Re- Application no CP 16-001

Please accept this submission regarding the construction of a rock armoured revetment wall which forms the estuarine edge of Lots 1 and 2 DP 1209371- 46 Arrawarra Beach Road Arrawarra.

RE: Coastal Protection Works – 46 Arrawarra Beach Rd, Arrawarra 2456

DA CP16-001

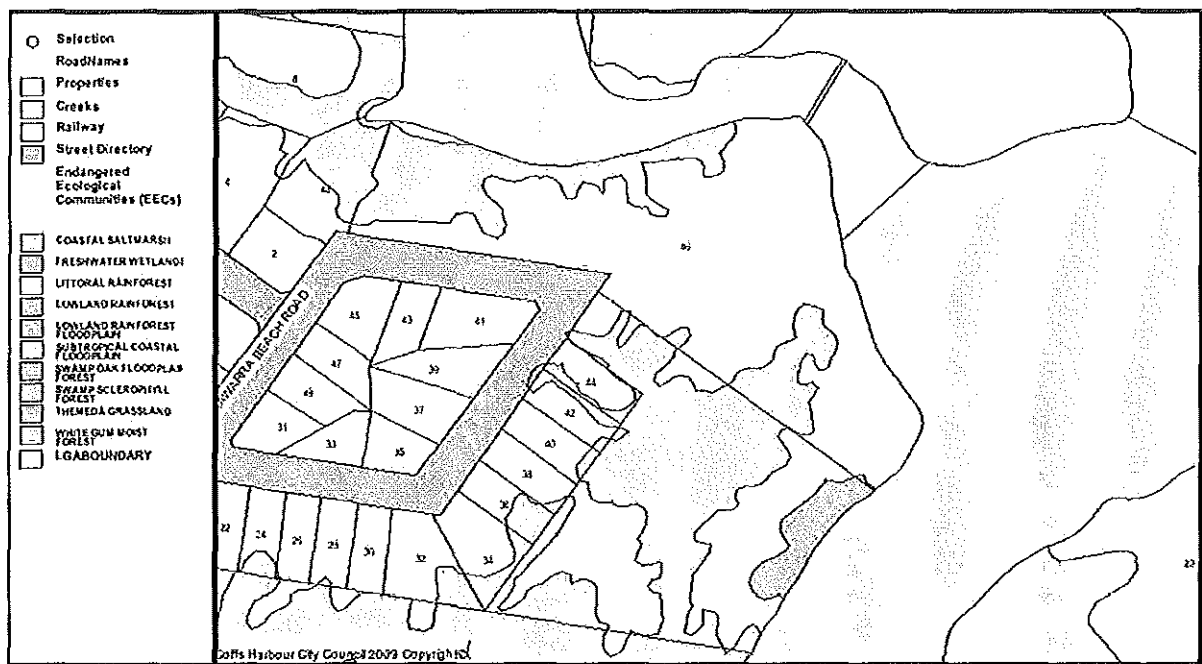
I reject the accuracy of the statement made about the location of the littoral rainforest. On page 33 they report it *'is separated by over 50 m of estuary/waterway'* and yet on page 136 it states *'Vegetation meeting the floristic criteria of this EEC does not occur on the site. A patch of littoral rainforest occurs within 100m, but the proposal has nil impact'*. This is a large discrepancy in the location of this important environmental feature. Furthermore I find the position shown on the provided Illustration 3.2 SEPP 14 and SEPP 26 shown below as confusing it appears to be located on the sandy beach.

Yet on page 133 Figure 6: CHCC EEC mapping of the site the important littoral forest (1 of only 2 in the Local Government Area) is clearly defined as encroaching on the bank of Yarrawarra Creek opposite the site of the proposed wall.

One must wonder if illustration 3.2 was designed to mislead or a legitimate error. I maintain the information supplied is inaccurate. The distance of 100 meters is incorrect and 50 meters is also considered excessive. I understand the littoral rainforest is closer than the figures indicated and could come under threat by the building of the proposed revetment rock wall. Photographic evidence exist revealing hastened loss of the northern bank since the installation of the current rock gabion wall, with a considerable amount of public reserve disappearing. The actual location should be clearly defined by the proponent and any projected impact should be clearly defined. In addition identified indigenous artefacts exist on adjacent land. It is inconceivable that approval could be granted without a thorough investigation into the possible risk to adjoining land that has extreme environmental and cultural significance.

3.2 Scale Problem of the Revetment Wall

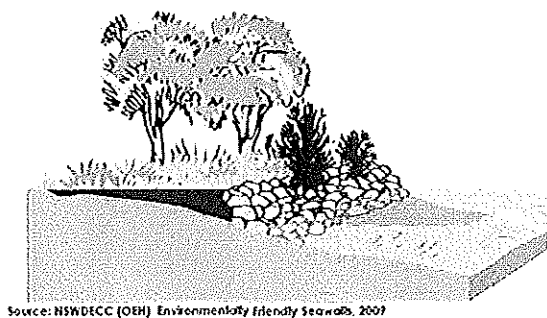
There should be no question that the proposed revetment wall represents a massive structure compared to the existing gabion wall. The existing gabion wall provides scour protection to the toe of the embankment and is overtopped by large tides. In comparison, the proposed revetment wall is:

- Some 4 m high
- Made up of large boulders up to 3 tonne in size

- Extends some 90 m beyond the areas covered by the gabion to protection wall (CH 330 to CH 420 Survey Layout)
- The alignment extends into the creek to reclaim land previously lost to the migration of the creek (e.g. some 60 m from CH69.49 to CH 130.968 Drawing No15-847NSW-09 Rev. A)
- Acts as a retaining wall for filling substantial areas of the site that are subject to flooding.
